June 2022 Product Shipping Configuration Change Notice For Poly VVX Phones

Engineering Advisory 210826

April 2022 | 3725-47130-013B

Example VVX 350 Console Label and Revision Code

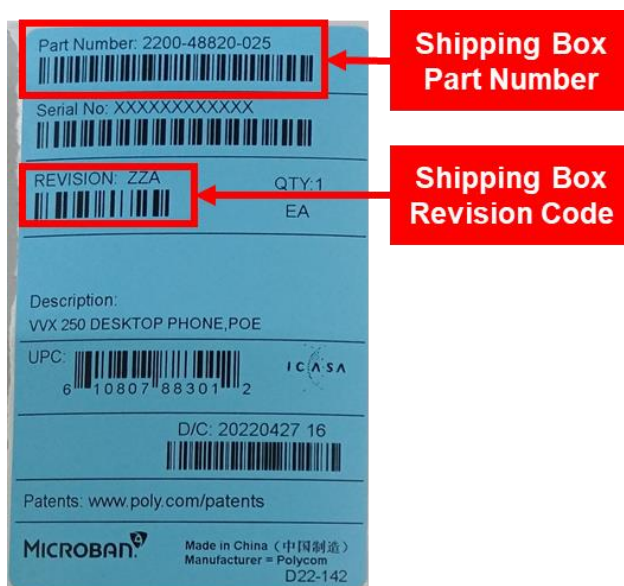
You can determine whether your phone includes the new hardware changes and software by examining the color of the shipping label, the part number and console revision listed on back of the phone, and the part number and console revision listed on the shipping boxes, as shown in the following figures.

If the information on your VVX x50 series phone console and shipping box does not match the information in the table in the section [Downgrade Limitations for Poly VVX x50 Series Phones](#), it is not a VVX x50 series model with the new hardware revision.

Example VVX 450 Web Configuration Utility

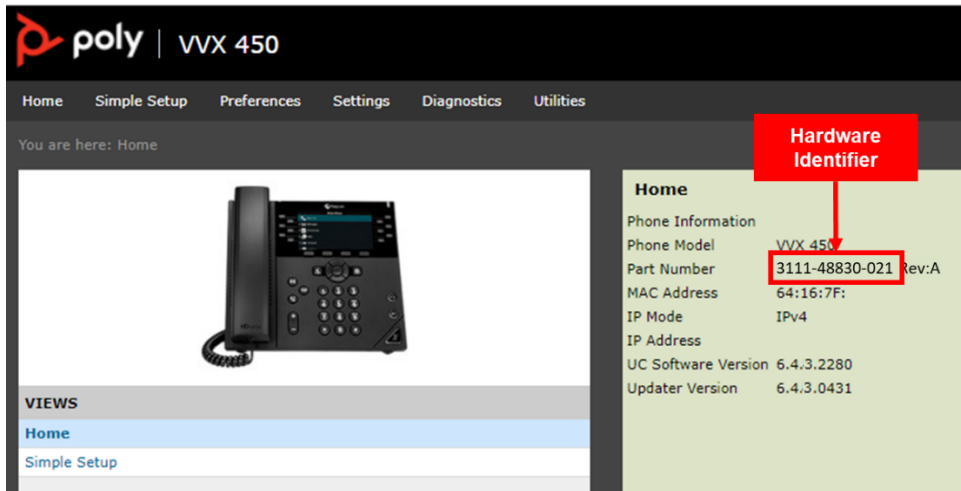
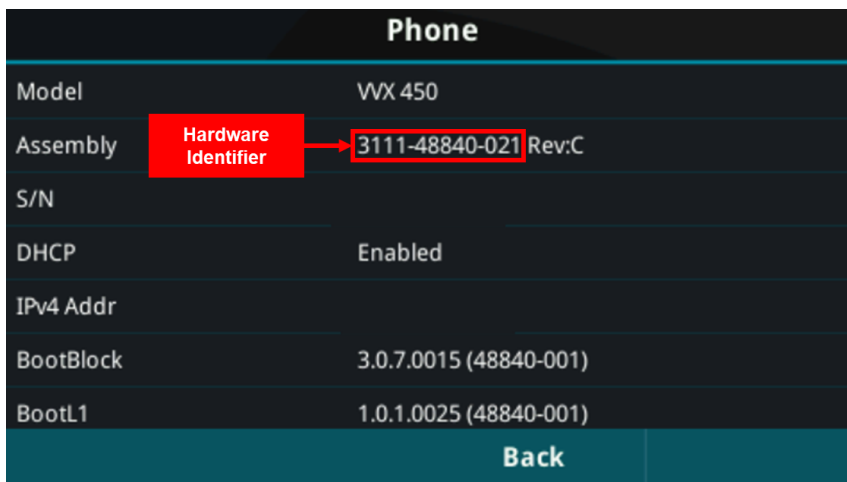
You can also identify a phone with the new hardware revision by examining the Hardware Identifier displayed in the phone's Web Configuration Utility and Phone UI as shown in the following figures.
